# SB-202301-001

VTX A12 RIGGING UPGRADE

Type: Service Bulletin Number: SB-202301-001 Topic: VTX A12 Rigging Upgrade Distribution Date: March 3, 2023 Copyright<sup>®</sup> 2023 by HARMAN International; all rights reserved

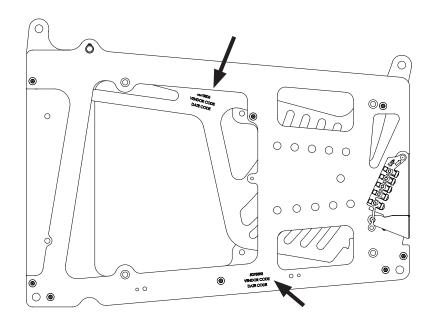
The A12 angle lock is a ratchet mechanism consisting of a set of teeth and pins. Depending on the angle selected by the user, a set of pins engages with the proper teeth to lock the angle. Due to manufacturing tolerances, the dimensions of some A12 rigging plates can vary to the point that an incorrect set of pins can engage when the load exceeds a certain threshold. This results in a condition where the mechanism jams and cannot be opened. The range of these dimensional variances are in the sub-millimeter range and cannot be seen by eye or easily measured without sophisticated equipment.

Several improvements have been implemented to eliminate this issue. Manufacturing tolerances are now tightly controlled, and parts are thoroughly inspected to ensure that out of spec parts are rejected at the time of manufacturing. More importantly, **a geometry change has been implemented** to the A12 inner rigging arm to complete eliminate the possibility of this condition.
